**Updated Vapor Mitigation System Design Drawings and Specifications
39155 and 39183 State Street
Fremont, California**

SUBJECT: Updated Vapor Mitigation System Design Drawings and Specifications
State Street Center
Fremont, California

Attachment 1 – Geo-Seal Elevator Pit Detail

Attachment 2 – Vapor Mitigation System (VMS) State Street Center On-Grade Townhomes
(June 15, 2016 Plan Set)

Geo-Seal Elevator Pit Detail
State Street Center
Fremont, California

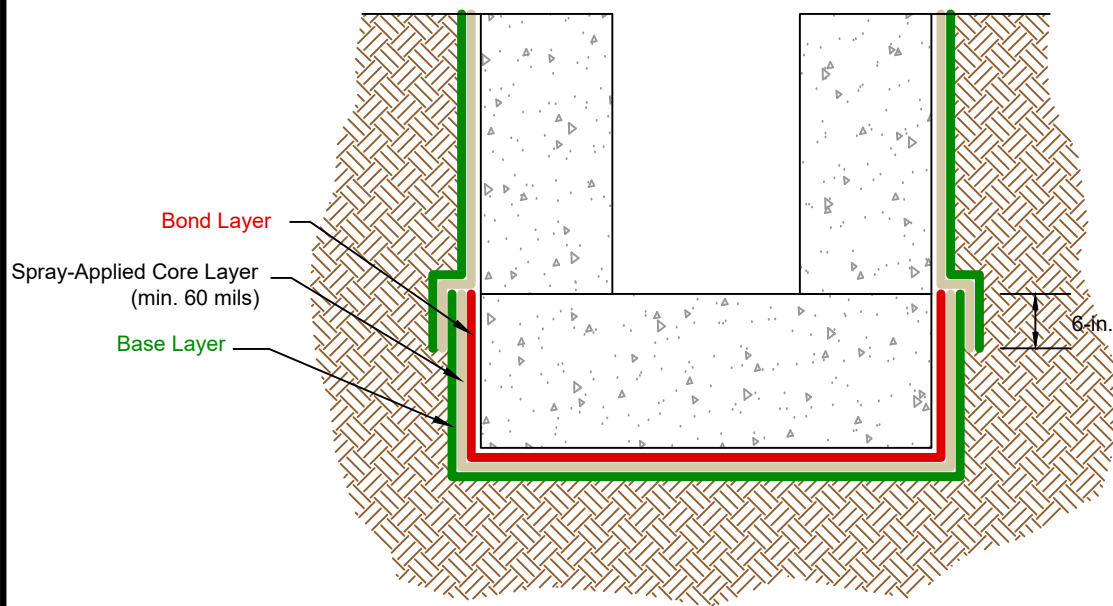
Attached is: (1) an elevator pit detail for Building A that was not included previously in the VMS Report, and (2) updated Vapor Mitigation System (VMS) design drawings for the on-grade townhomes that have been developed based on the more recent building design drawings. The VMS drawings for the on-grade townhomes have been revised based on the new building layouts and now include using 3-inch diameter Schedule 40 PVC pipe inside the building and 3-inch diameter galvanized steel pipe at the rooftop (instead of 4-inch diameter cast iron pipe as specified in the VMS Report) for the vent risers.
